The following information and check list are furnished as a guide for the insertion of new sheets for Amendment 28 into the Preliminary Safety Analysis Report for the Skagit/Hanford Nuclear Project. This material is denoted by use of the amendment date in the upper right-hand corner of the page.

QUESTIONS AND RESPONSES  
SKAGIT/HANFORD SITE

## QUESTION 231.14

PUGET SOUND POWER & LIGHT COMPANY SKAGIT / HANFORD NUCLEAR PROJECT PRELIMINARY SAFETY ANALYSIS REPORT
<b>TOTAL BOUGER GRAVITY ANOMALY MAP MAY JUNCTION AREA</b>
FIGURE 231.14-2

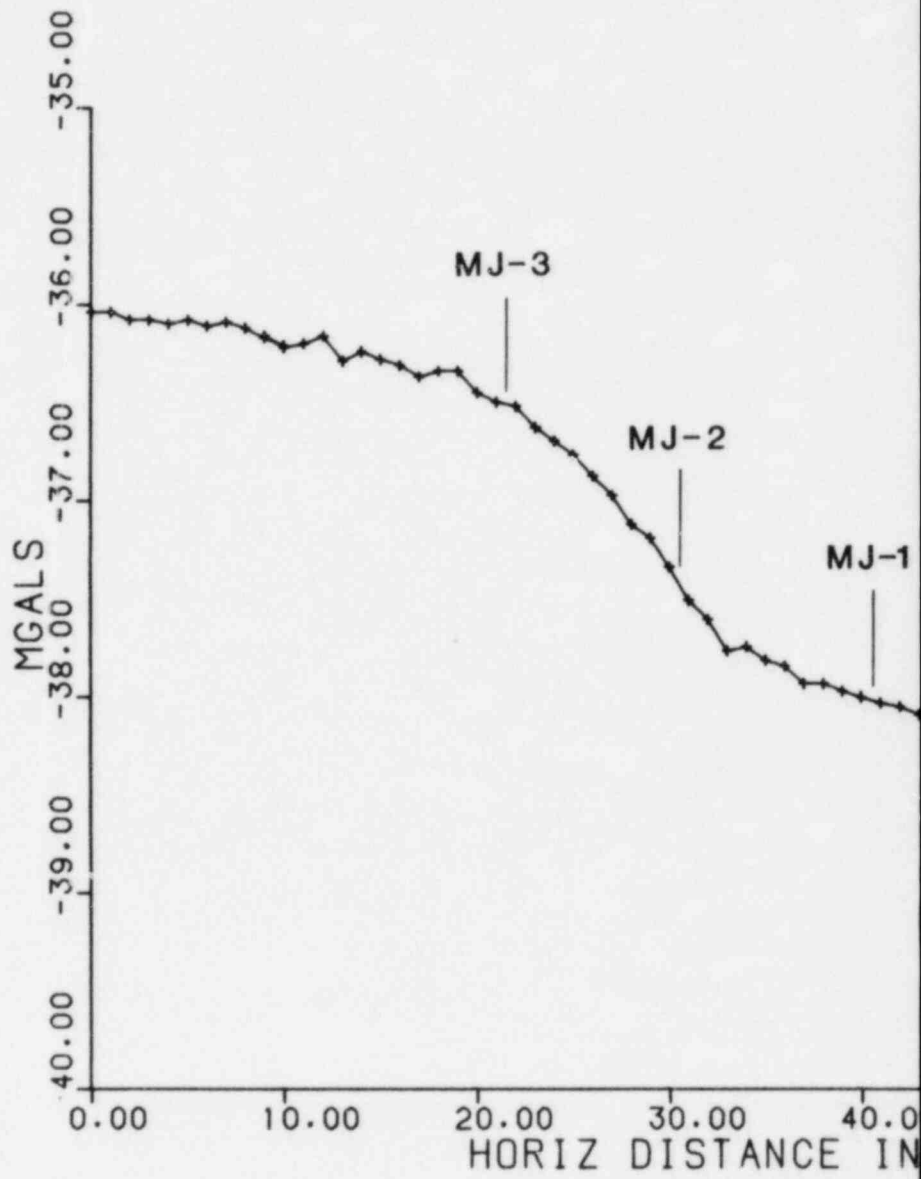
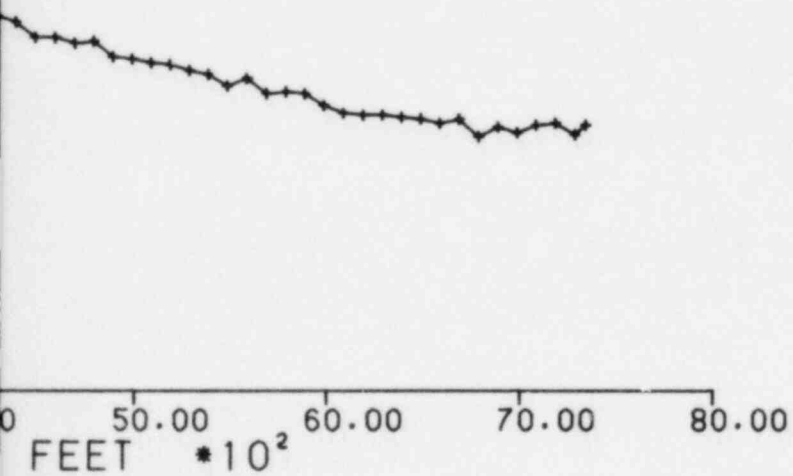
The Applicant will conduct a core boring program of sufficient scope to determine if the May Junction monocline is fault controlled. If fault controlled, this program should provide sufficient new subsurface evidence demonstrating that the fault is not capable. This may include other subsurface techniques and information to supplement the core borings. This program should be of sufficient scope to define the attitude, sense of movement and age of last movement of the fault and be designed to carefully recover and define the overlying formations in this area.

New gravity stations were established in Sections 32 and 33 of T13N, R27E, approximately 1 mile south of Gable Mountain (Figure 231.14-1), along nine new traverse lines (8A-8H, 8J) and portions of Lines 8 and D at 100-foot station intervals. All gravity stations were surveyed and both vertical and horizontal control provided to the nearest 0.1 foot. The newly acquired data were evaluated in profile. They were also combined with the NESCO data set (S/HNP PSAR, Appendix 2K) to produce a total Bouguer gravity anomaly map (Figure 231.14-2). The gravity anomaly contours on the May Junction monocline are consistent with a north-south trending bedrock surface sloping gently and uniformly downward toward the east.
